WORK ORDER NON-CONFORMANCE / UPDATE

Item Name: Replacement Exterior Window For -111

DRAWING NO. D3290	TITLE REPLACEMENT WINDOW ASSEMBLY	REV. C	DART AEROSPACE LTD ENGINEERING ORDER		D.E.O. NO. D3290-C-1	SHEET NO. SHEET 1 OF 1	SCALE NTS
DRAWN <i>Q</i>	CHECKED <i>h</i>	MFG. APPR. <i>E</i>	APPROVED <i>W</i>		DE APPR. <i>h</i>		
DATE 09.09.18	DATE 09.09.18	DATE 09.09.18	DATE 09/09/21		DATE 09/09/21

PURPOSE:

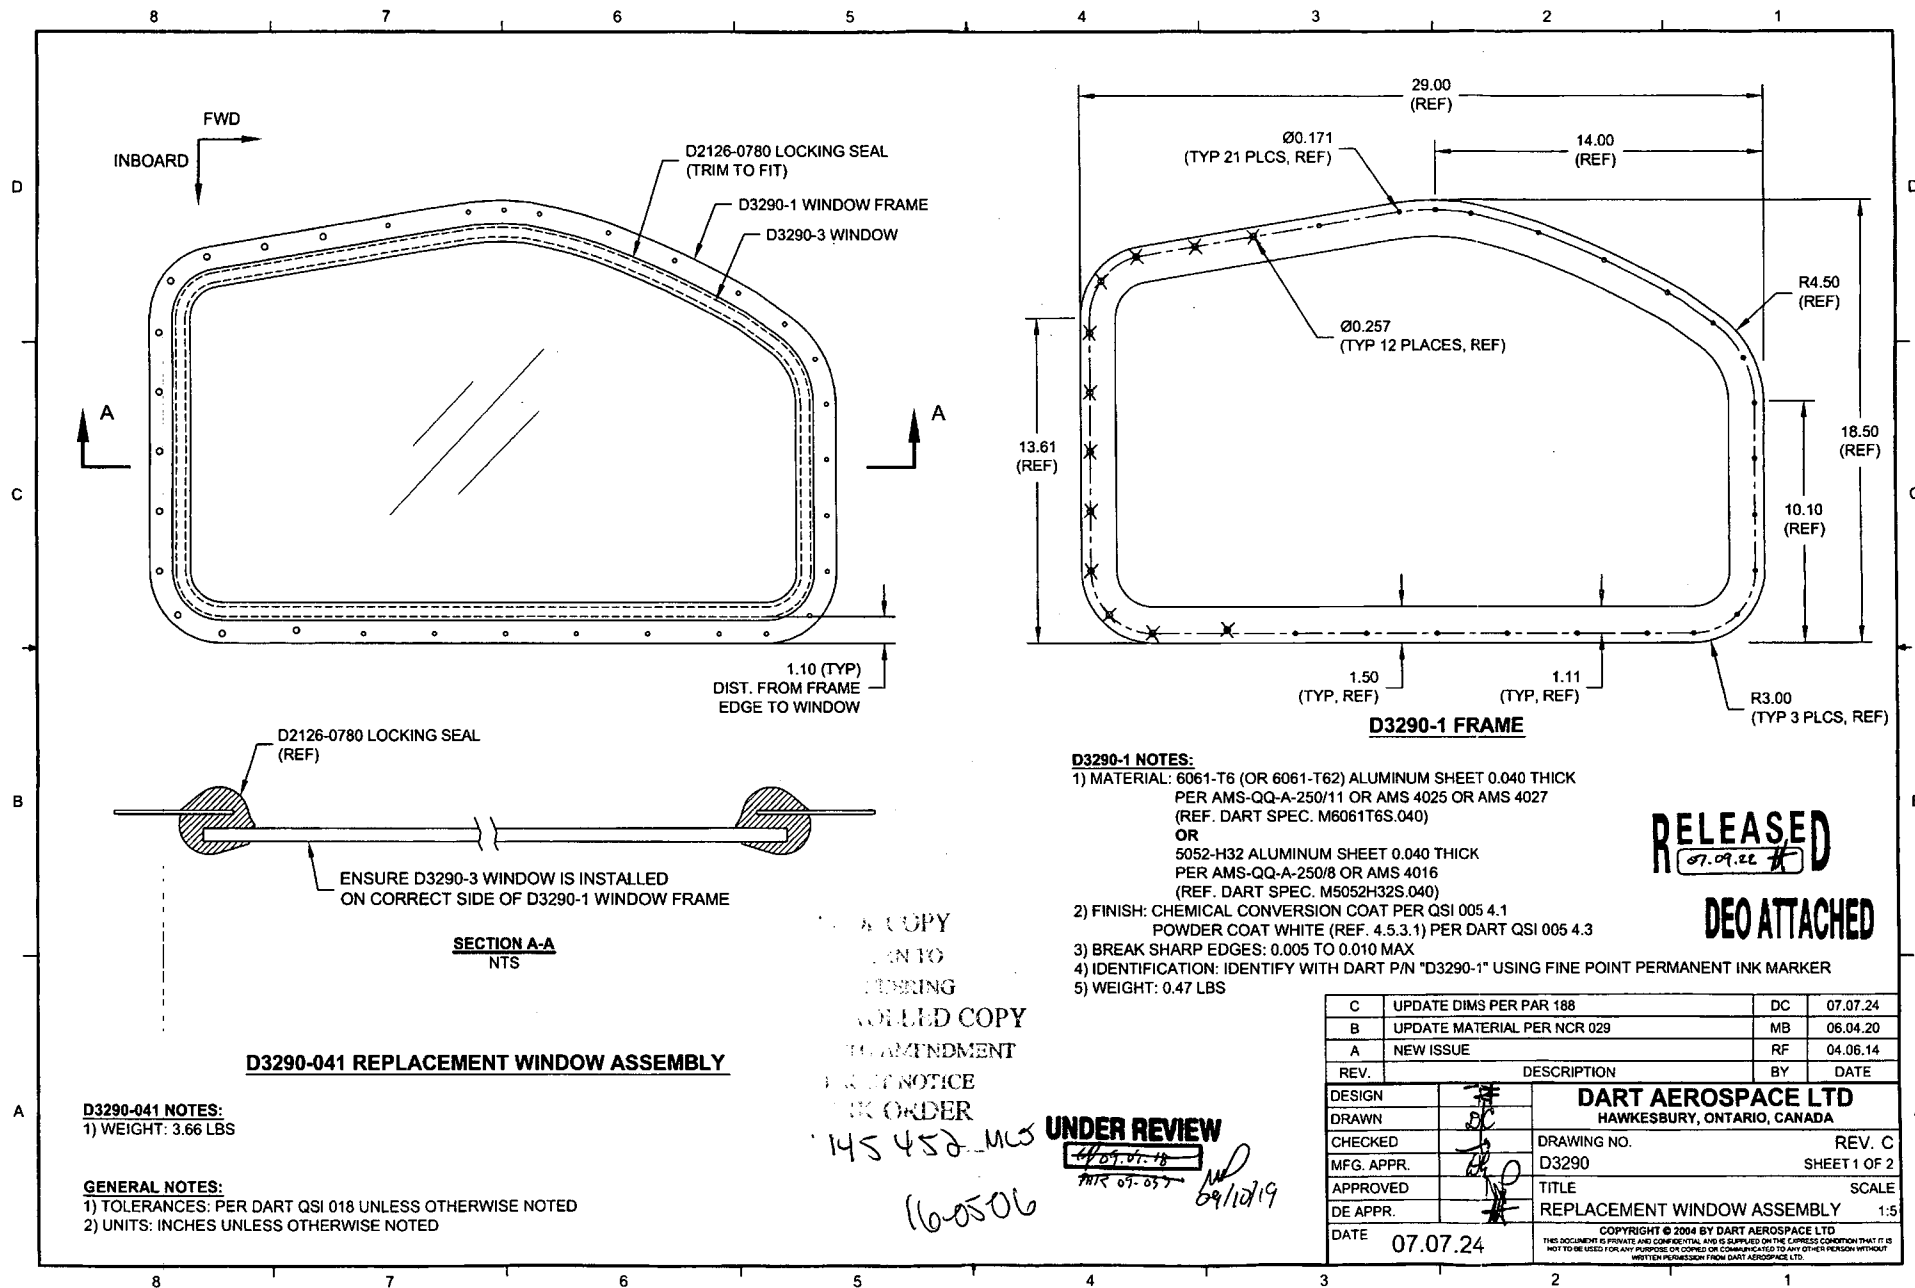
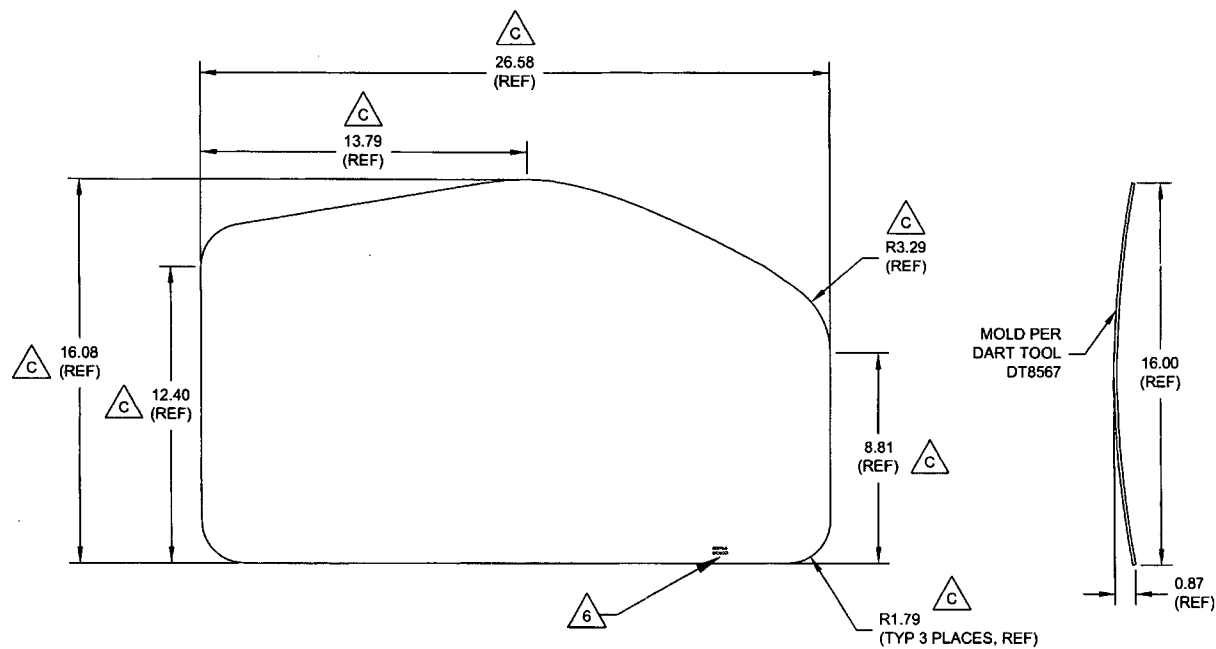
CHANGE MATERIAL THICKNESS OF D3290-1 FRAME TO 0.063 FROM 0.040. REF PAR 09-033.

CHANGE:

MATERIAL CALL-OUT OF D3290-1 FRAME ON SHEET 1 IS AMENDED AS FOLLOWS:

D3290-1 NOTES

- 1) MATERIAL: 6061-T6 (OR 6061-T62) ALUMINUM SHEET ~~0.040 THICK~~ 0.063 THICK (REPLACE)
 PER AMS-QQ-A-250/11 OR AMS 4025 OR AMS 4027
~~(REF. DART SPEC. M6061T6S.040)~~ REF. DART SPEC. M6061T6S.063 (REPLACE)
 OR
 5052-H32 ALUMINUM SHEET ~~0.040 THICK~~ 0.063 THICK (REPLACE)
 PER AMS-QQ-A-250/8 OR AMS 4016
~~(REF. DART SPEC. M5052H32S.040)~~ REF. DART SPEC. M5052H32S.063 (REPLACE)
